# Technical Service Bulletin

## 17 Engine oil consumption too high, 2.0L TFSI (EA888) Model Year 2009 - 2011

17 15 60 2027731/7 April 24, 2015. Supersedes Technical Service Bulletin Group 17 number 15-54 dated January 29, 2015 for reasons listed below.

Model(s)	Year	VIN Range	Vehicle-Specific Equipment
A4, A5, A5 Cabriolet, Q5	2009 - 2011	All	2.0L TFSI

**Figure 1.** 01 – Oil consumption measurement (electronic measurement).

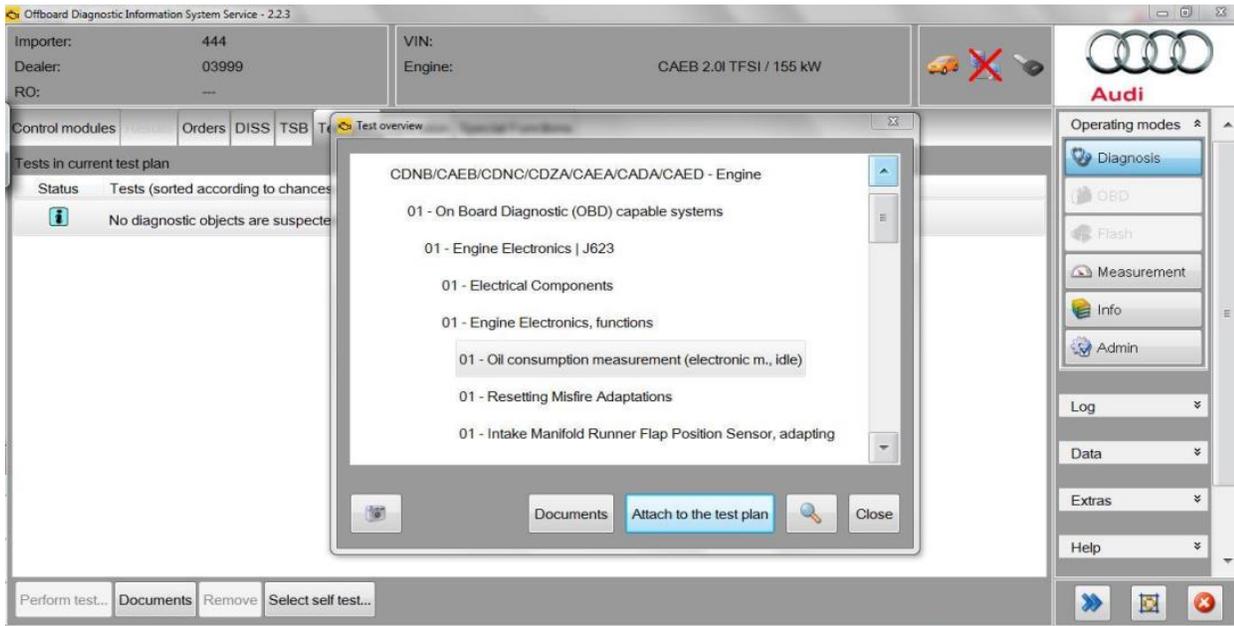
- Start Diagnosis. Select *Self-test >> Powertrain (repair groups 10-39) >> 01 On Board Diagnostic (OBD) >> 01 Engine Electronics >> Engine Electronics, functions >> 01 Oil consumption measurement (electronic m., idle)*.

- Follow the GFF test plan, *Start oil consumption measurement* exactly and observe all notes and cautions.
